HISTORIC AND DESIGN REVIEW COMMISSION

HDRC CASE NO: 2023-498
ADDRESS: 819 E MULBERRY AVE
LEGAL DESCRIPTION: NCB A-52 BLK LOT 35
ZONING: C-1 CD, RIO-1
CITY COUNCIL DIST.: 2
APPLICANT: Jennifer Adams/Core States Group
OWNER: BIG DIAMOND INC
TYPE OF WORK: Construction of a fuel pump canopy
APPLICATION RECEIVED: October 25, 2023
60-DAY REVIEW: December 24, 2023
CASE MANAGER: Jessica Anderson
REQUEST:

The applicant requests a Certificate of Appropriateness for approval to construct a 17'x69' fuel pump canopy.

1 SIDE FASCIA DETAIL
SCALE: 1"=1'-0"

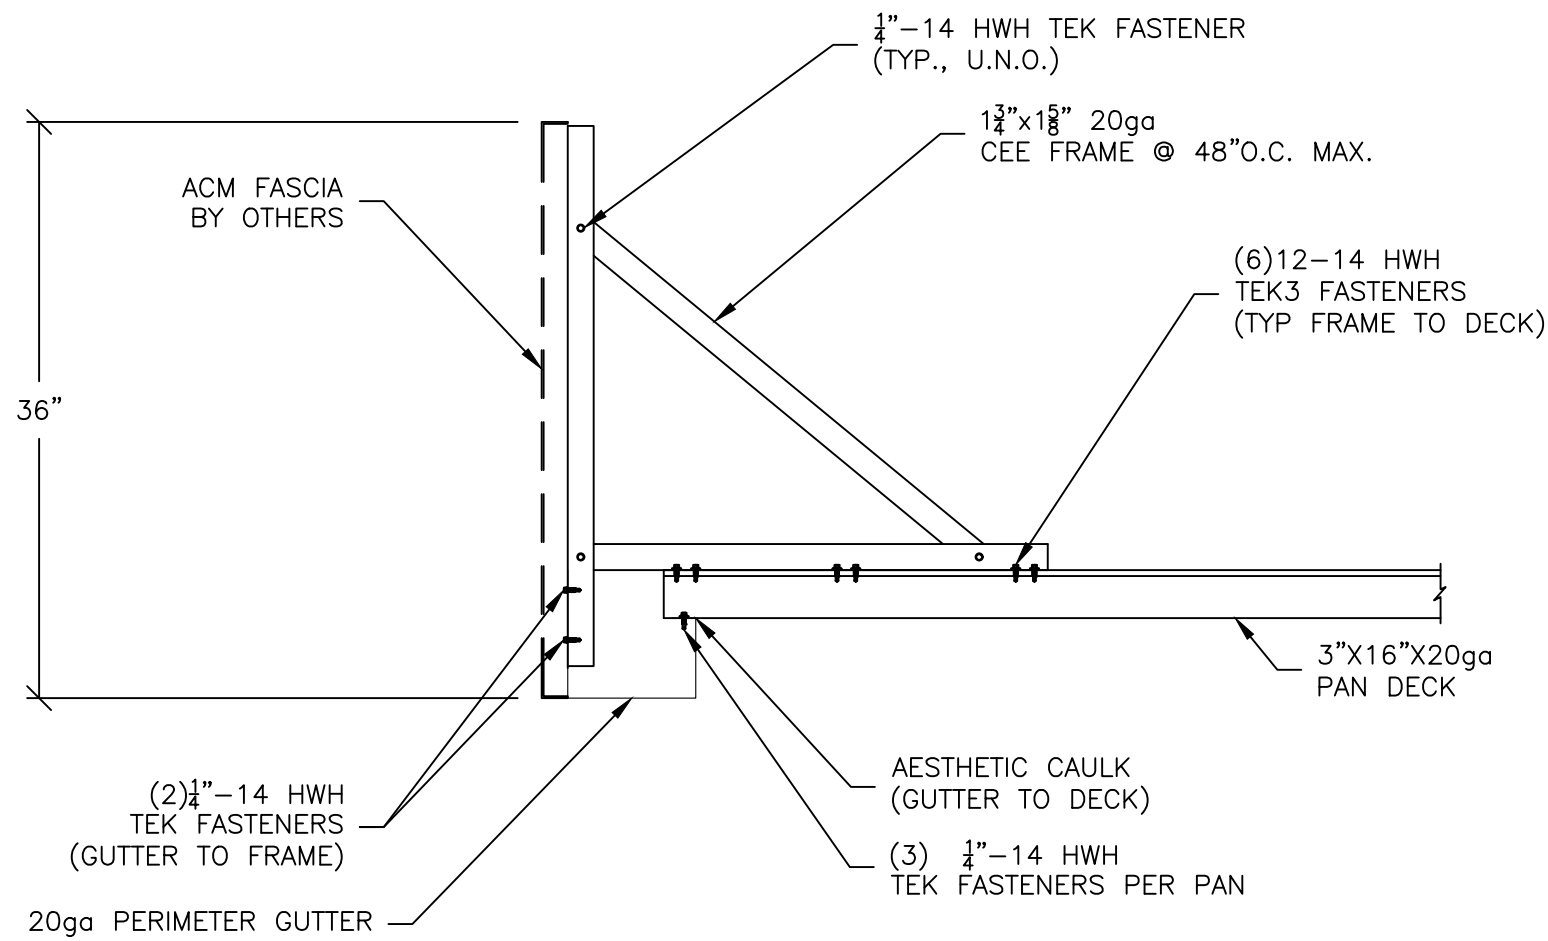
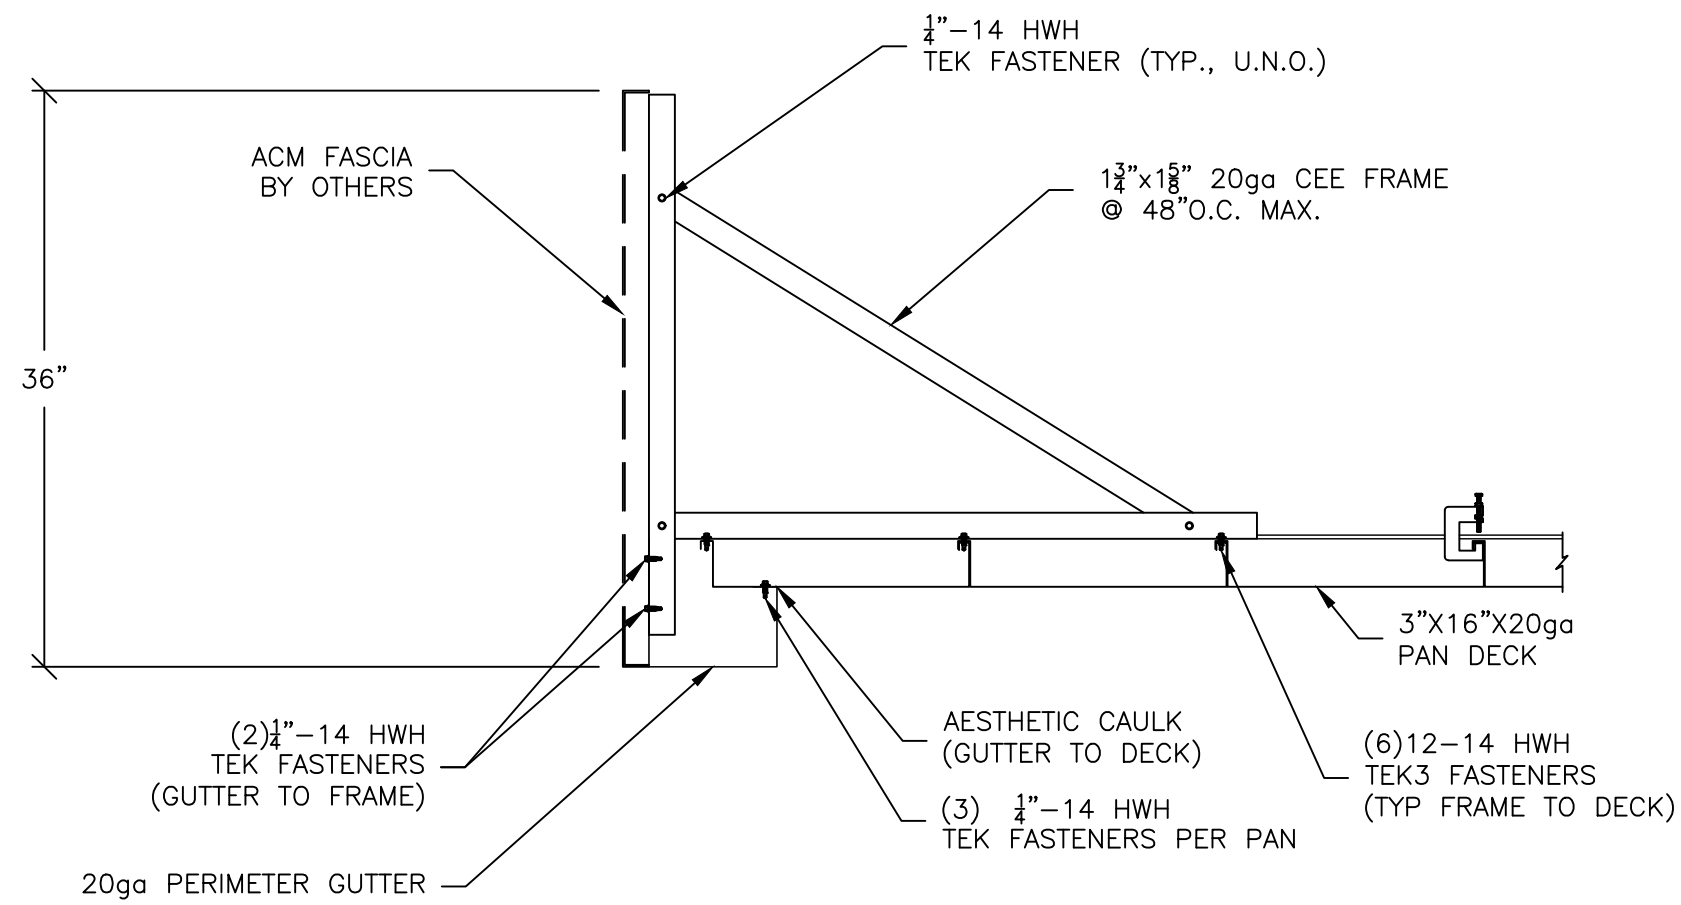
- c. FUEL PUMP CANOPY (Design) – The applicant has noted metal canopy fascia on each façade of the proposed fuel canopy. Each fascia will feature three 3' feet in height. Staff finds that these should feature a non-gloss finish and be painted to complement the existing building façade. The applicant has not specified finishes for the proposed columns at this time. Staff finds that all metal elements of the canopy be finished in a non -gloss material and be comparable to the existing building in color.

Staff recommends approval to construct a 17'x69' fuel pump canopy, based on findings a through c, with the following stipulation:

- i. That the applicant submits a lighting diagram to staff for review and approval.
- ii. That a signage plan be submitted to staff for review in a separate application for a Certificate of Appropriateness for review and approval.
